Service Bulletin

Group	Number	Version
20-0	11	03

3.0 Liter Engine Upgrades

LK, BY, WT, and EF Models

gr970440

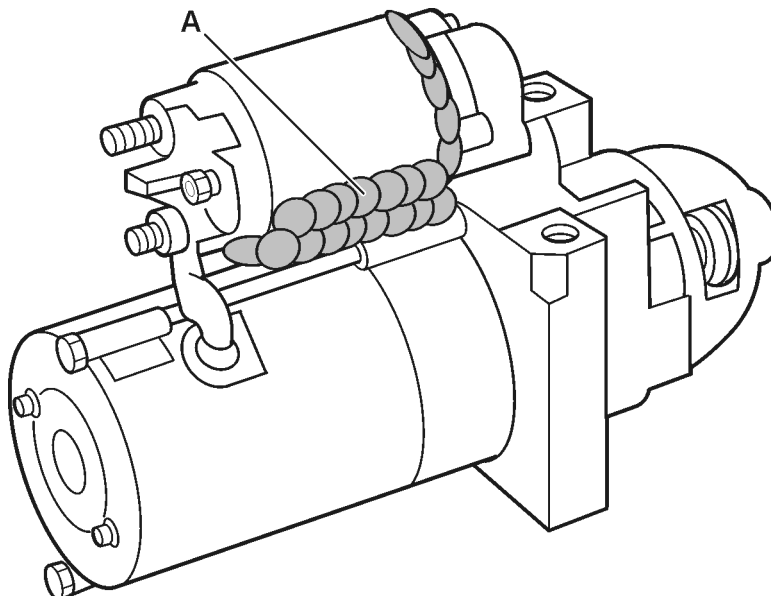
Starter Motor

DANGER! Do not substitute an automotive type starter. The Volvo Penta starter motor meets U.S. Coast Guard regulations for external ignition proof operation and marine use. The Volvo Penta starter is specially designed not to cause ignition of fuel vapors in the bilge or engine compartment. The use of automotive type starters can result in fire and explosion.

1. Disconnect the battery ground cable at battery and disconnect all wires at solenoid terminals to prevent sparks in engine compartment.
2. Remove the nut from the starter support bracket. Take out the starter mounting screws and remove the starter assembly.
3. Clean the surface of the starter with electrical contact cleaner or equivalent.
4. Using silicone or RTV sealer, apply a bead in the area indicated below **A**. Seal the gap all around the starter solenoid. Follow the sealant manufacturer's instructions and allow adequate drying time before reinstalling the starter.

1. To reinstall, position the starter assembly on the engine and start the mounting hardware.
2. Snug hardware while holding the starter squarely against its mounting surface. Tighten the screws to 30–36 ft. lb. (41–49 Nm).
3. Connect wires to solenoid and apply black Neoprene dip or equivalent to terminals to prevent corrosion.
4. Reconnect the battery ground cable at the battery. Attach the bell housing drain hose to the solenoid with a tie strap.
